Re: Turkey Point Unit 3
Docket No. 50-250
Order (EA-03-009) Relaxation Request
Examination Coverage of Reactor Pressure Vessel Head
Penetration Nozzles – Supplemental Data

**TURKEY POINT UNIT 3 RELAXATION REQUEST
FROM US NRC Order EA-03-009**

**“Hardship or Unusual Difficulty without Compensating Increase in
Level of Quality or Safety”**

RESPONSE TO REQUEST FOR ADDITIONAL INFORMATION

Figure 1: Typical RPV Nozzle UT Inspection "C" Scan with area of missed coverage identified by arrows and above the white horizontal line.

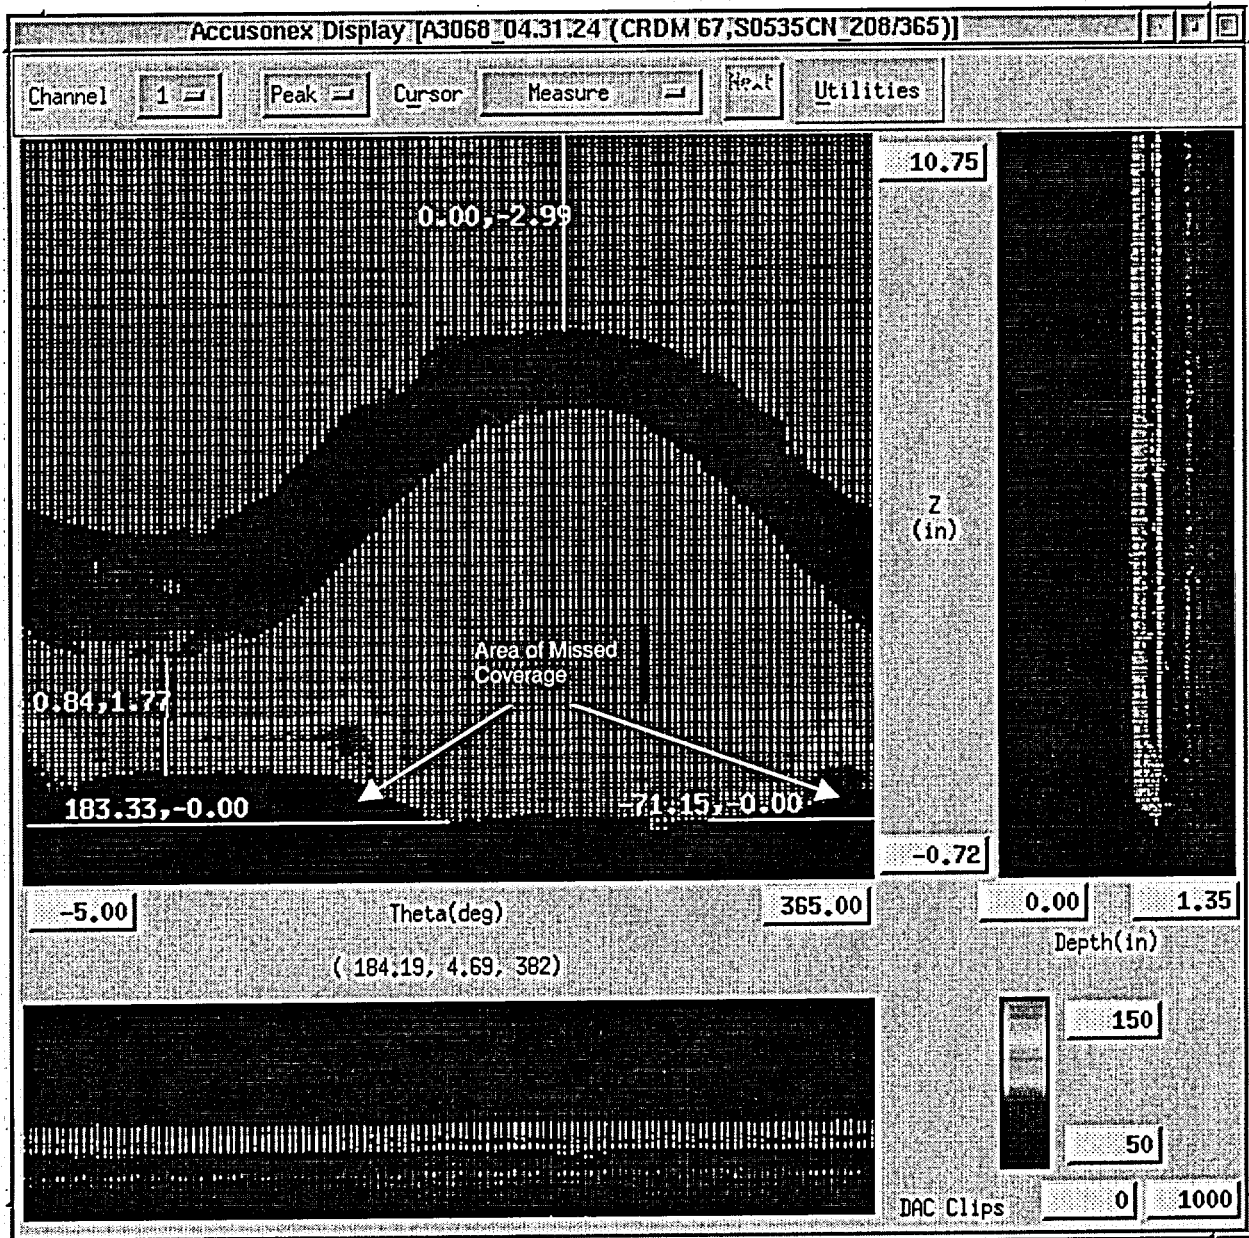
Question 3. In Figure 1 of the submittal, the degrees of missed coverage for control rod drive mechanism (CRDM) 67 are listed as 60.27 and 175.79 for a total of 236.06 degrees. In Table 2 of the submittal, a comment for CRDM 67 states "coverage below weld from 343 degrees - 170 degrees." What is the area of missed coverage for this nozzle, how is it determined and how does one reconcile the information provided in the C-scans with the table?

Previously, Figure 1 was included to depict a "typical" example for nozzle #67. The figure 1 that is included in the supplemented request is the actual C-scan for nozzle #67 that illustrates the circumferential extent of missed coverage. The extent of missed coverage at the bottom of the nozzle is determined by, in this case, adding the two numbers. Additionally, the total circumferential extent of missed coverage, in degrees, is now shown in Table 2 for every nozzle where coverage was less than 100%.

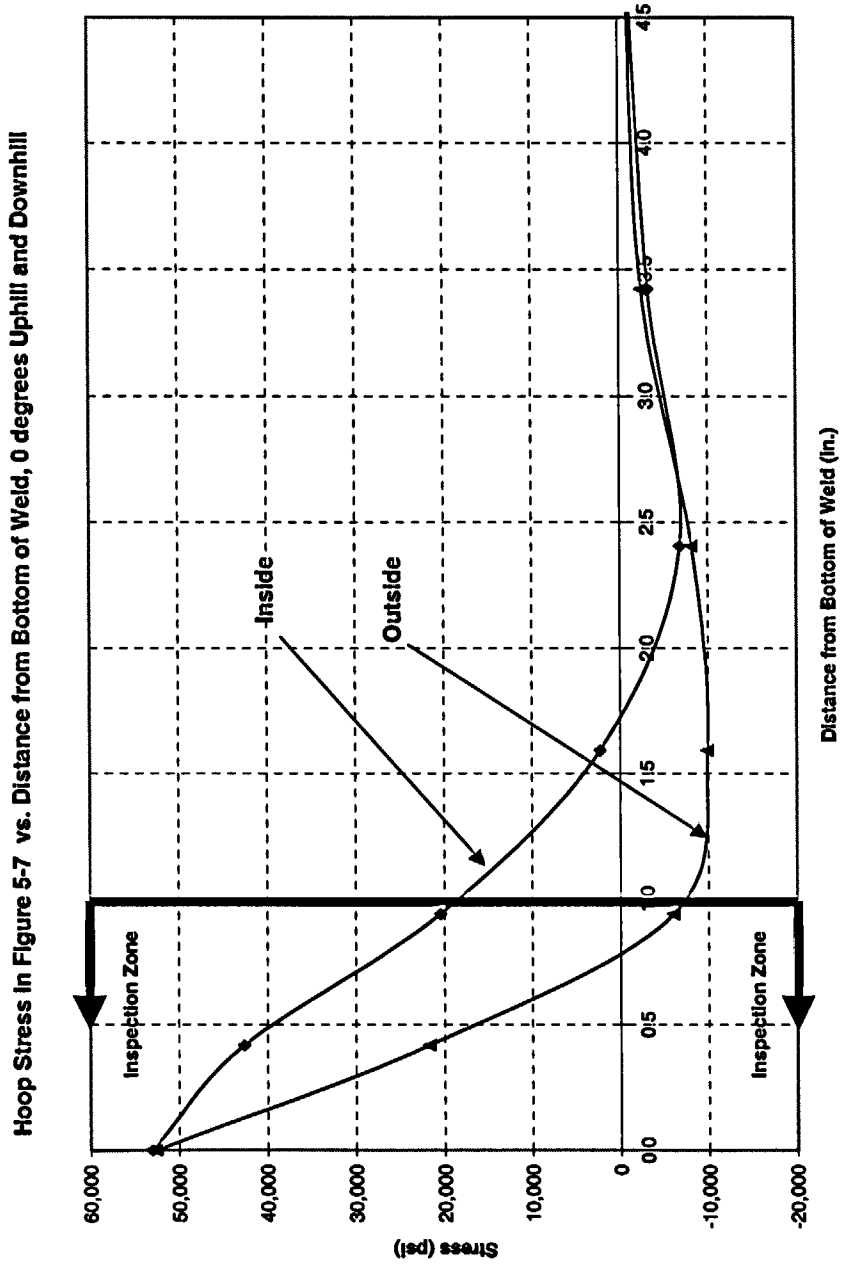
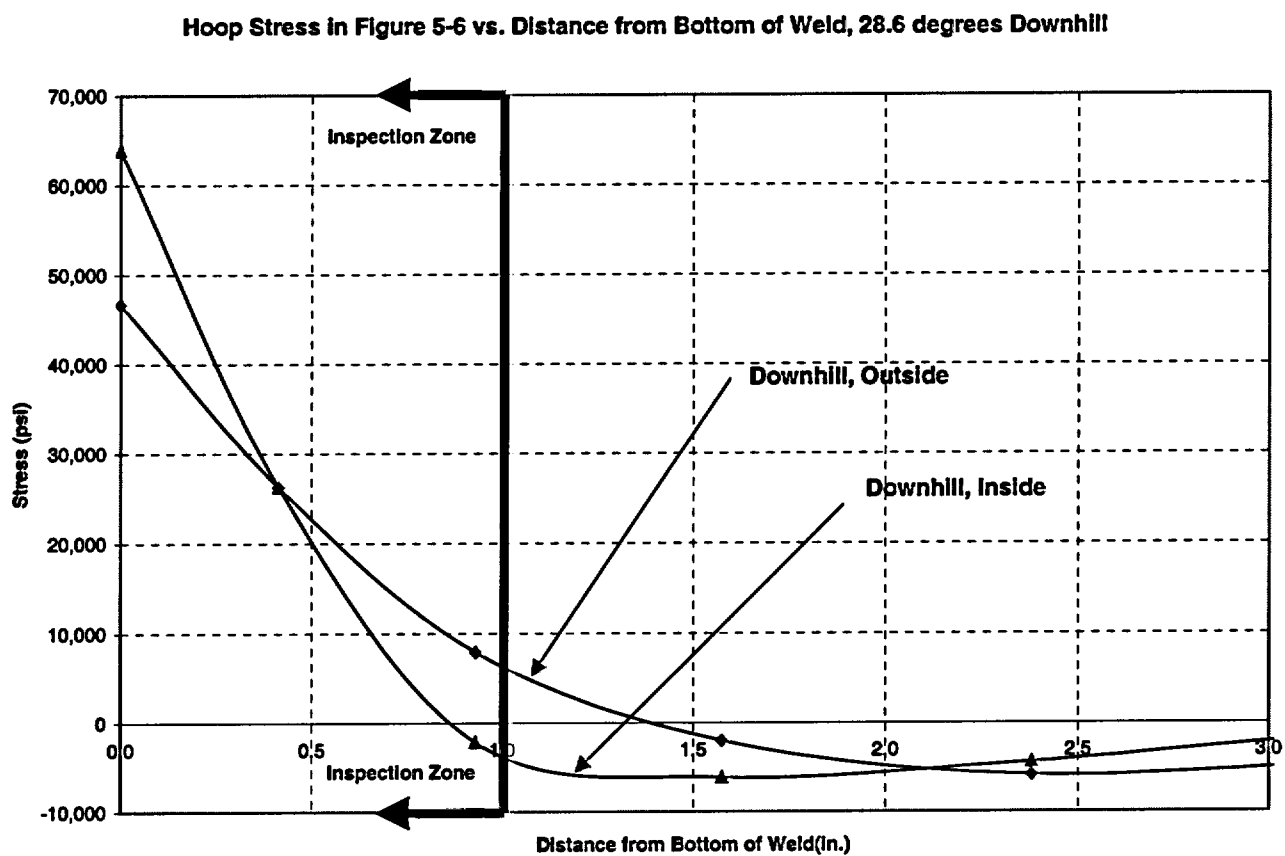
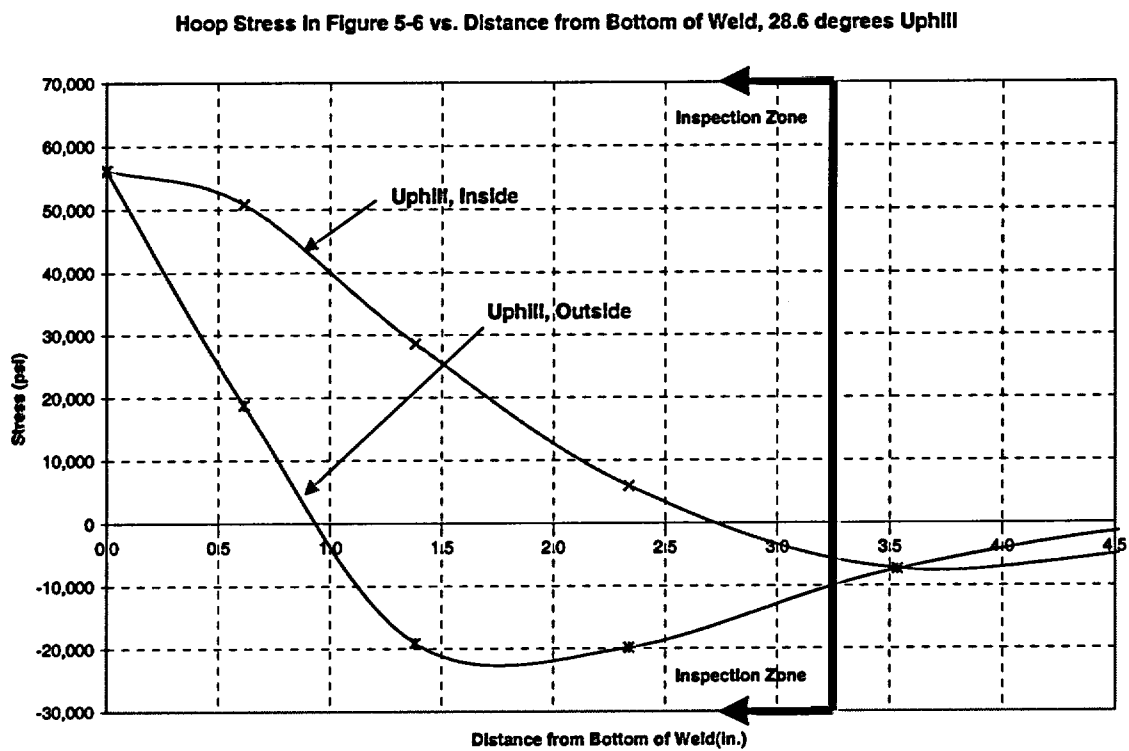
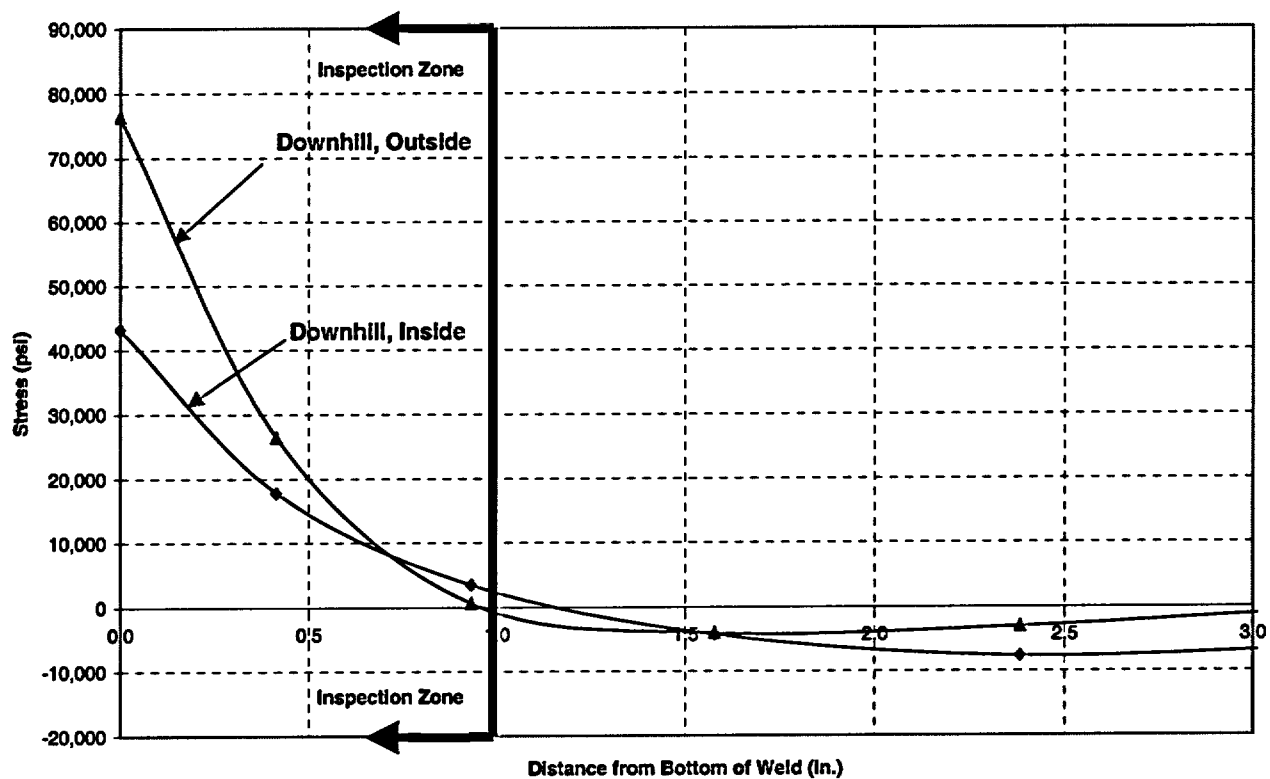
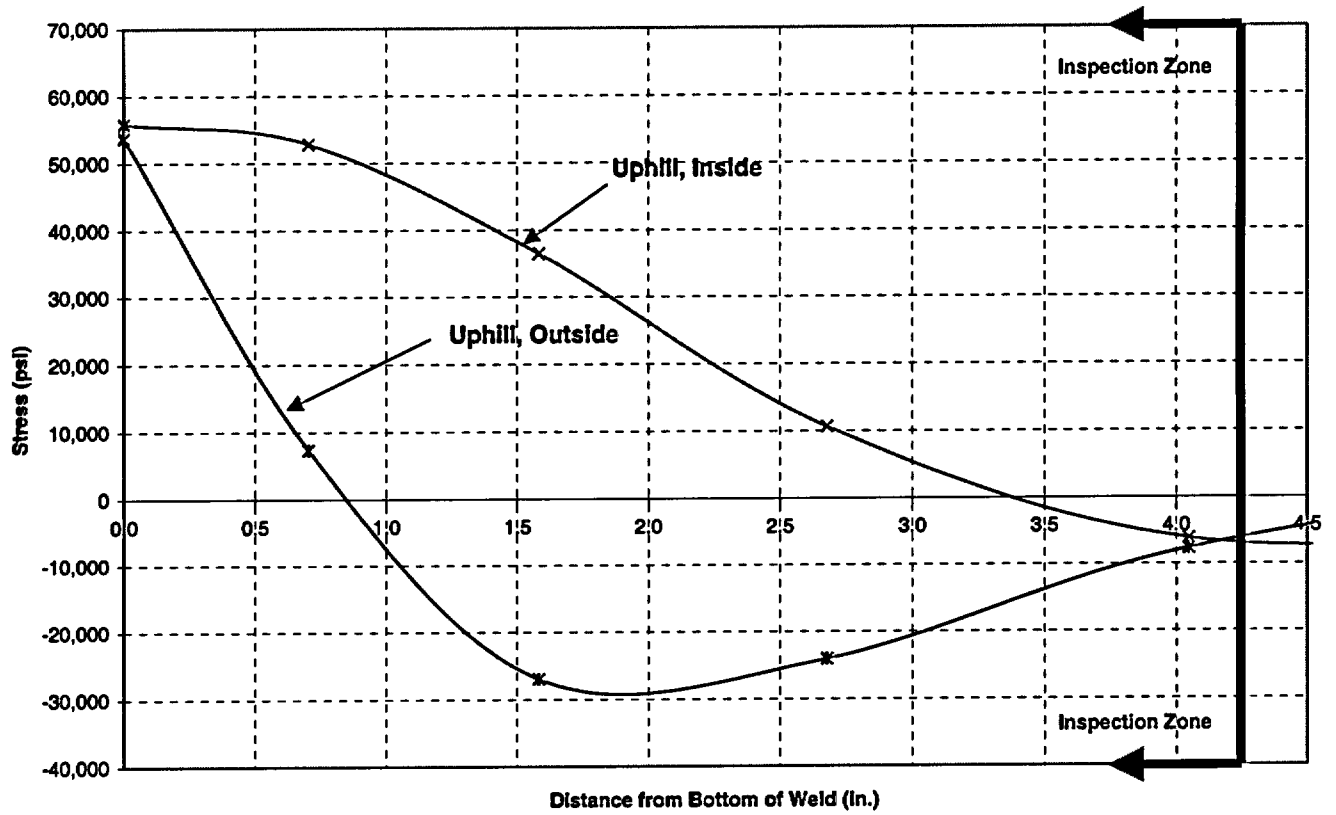
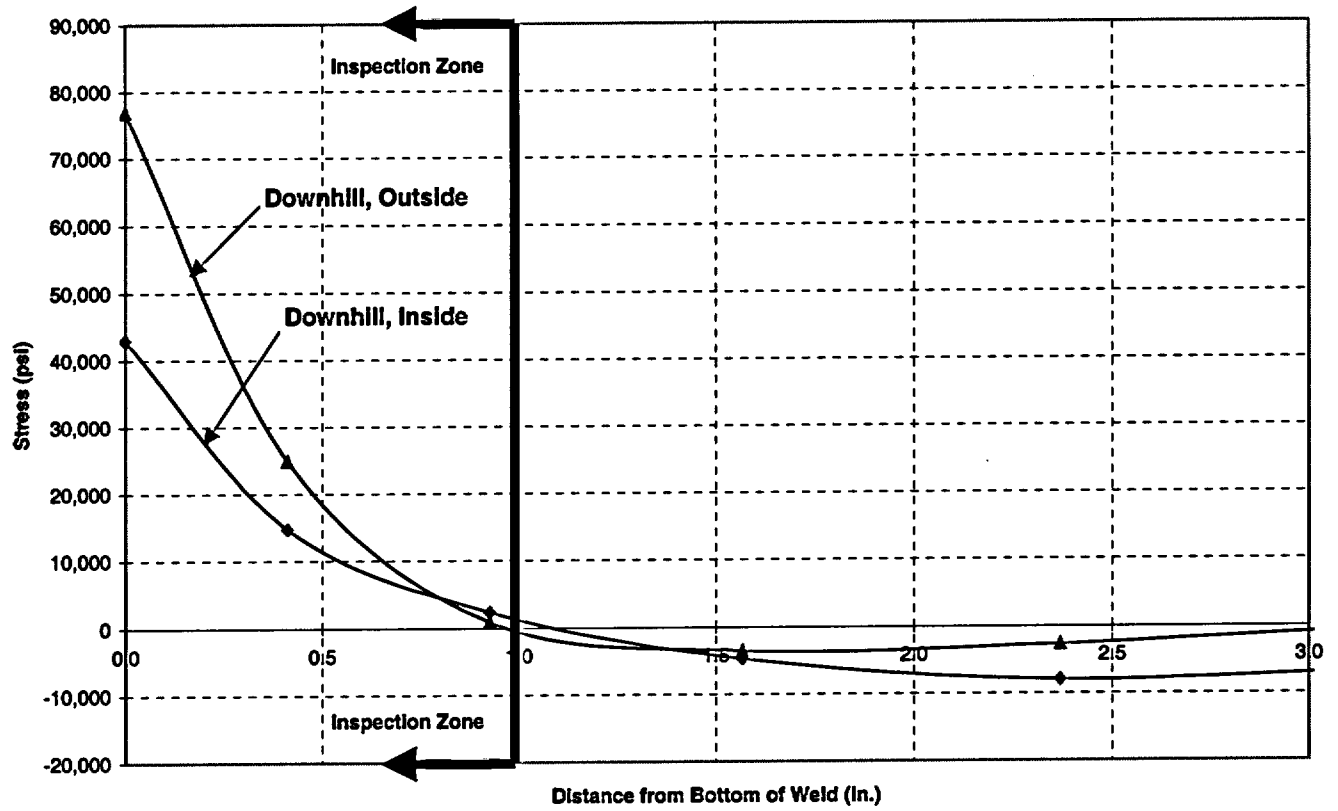
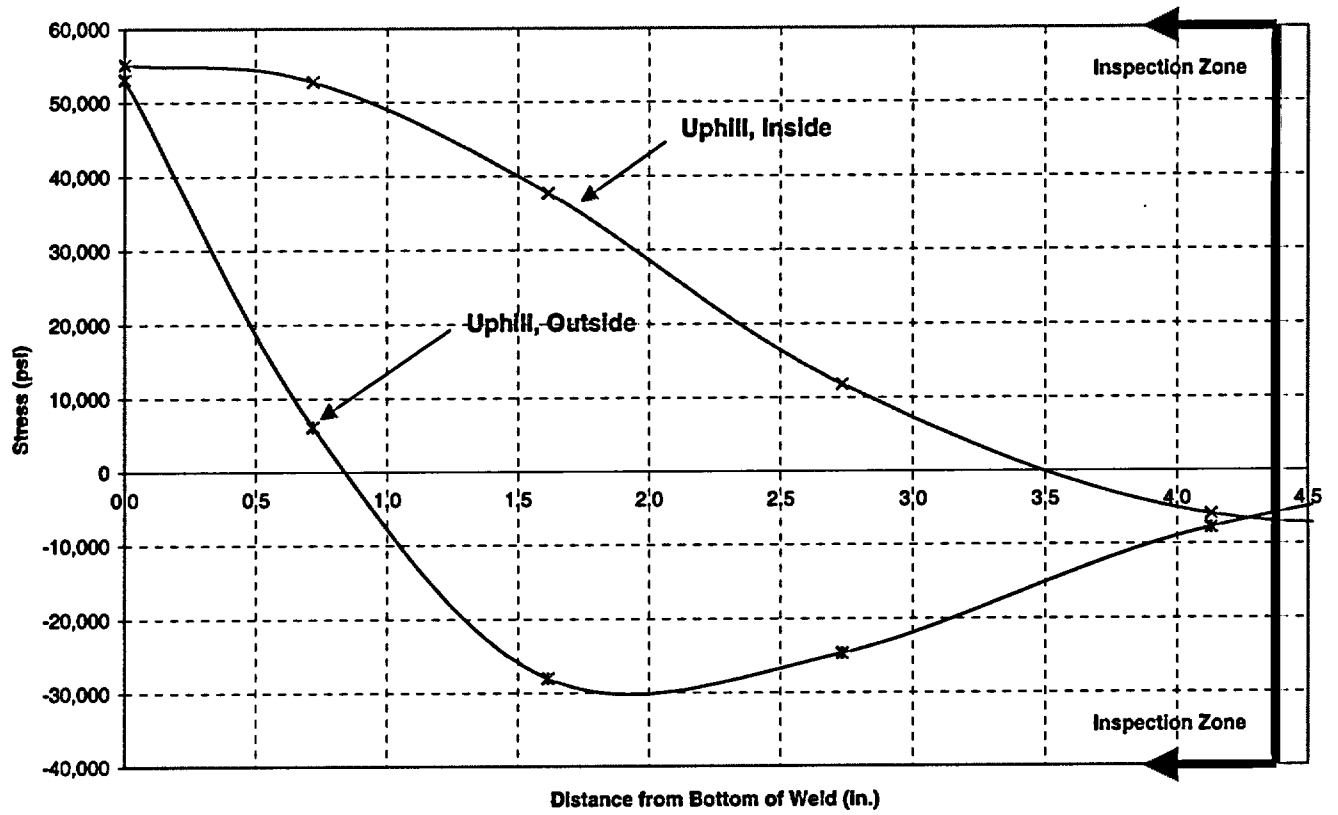
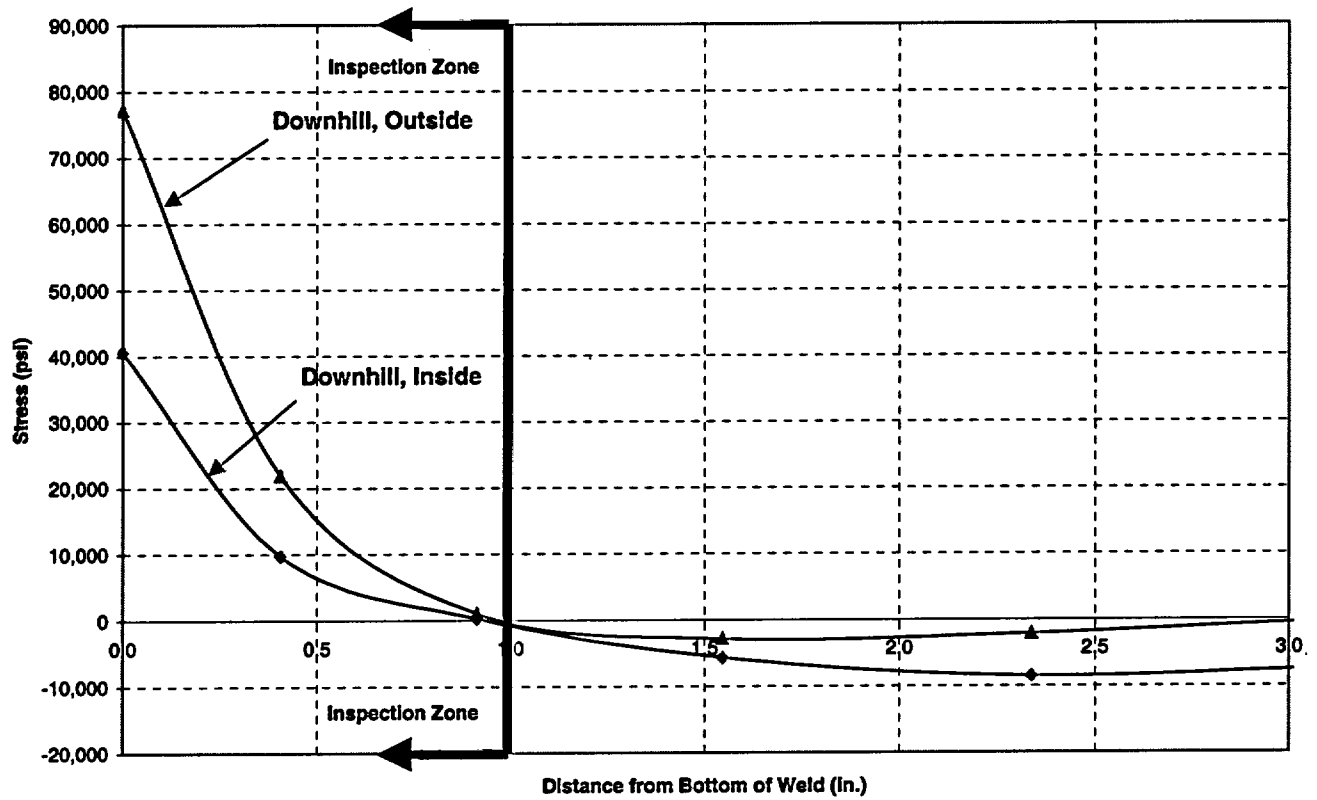
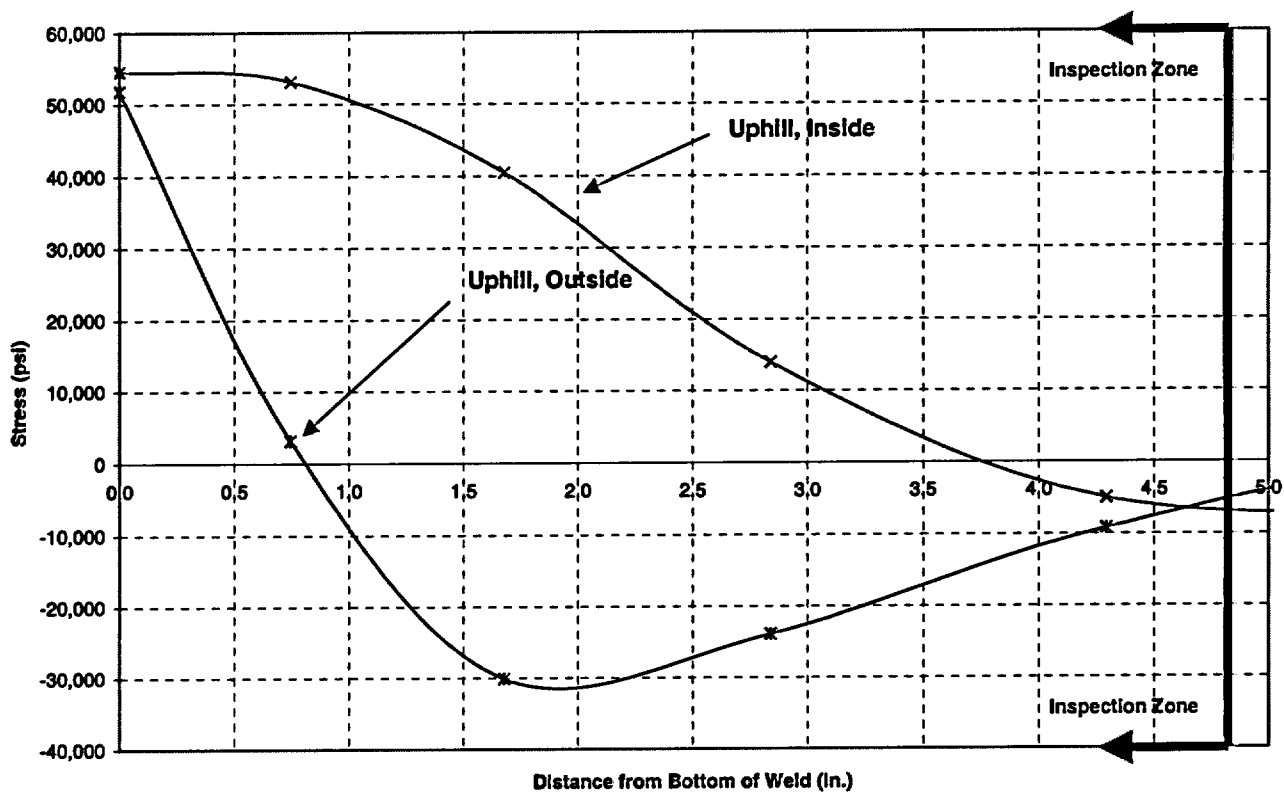
Question 1. In Figures 5-3 through 5-9 of WCAP-16027-P, what is the maximum hoop stress in the nozzle base material greater than one inch from the bottom of the weld? What material properties (i.e., yield strength) were used in these calculations?

The hoop stress distribution as a function of distance from the bottom of the weld shown in Figures 5-3 through 5-7 of WCAP-16027-P are provided in Figures 1 to 9. Hoop stress in Figure 5-8 of WCAP-16027-P for the head vent penetration below the weld is not available because the penetration does not extend beyond the attachment weld. Figure 5-9 of WCAP-16027-P is an axial stress distribution plot of CRDM (42.6°) and the corresponding hoop stress distribution as a function of distance from the bottom of the weld for this nozzle is given in Figures 8 and 9. Note that the minimum distance below the weld toe depicted on Table 2 typically occurs at the downhill side of the welds. Coverage at the uphill side is greater, and varies with the angle of the penetration. This difference in distance below the weld is approximated in Figures 1-9 contained herein.
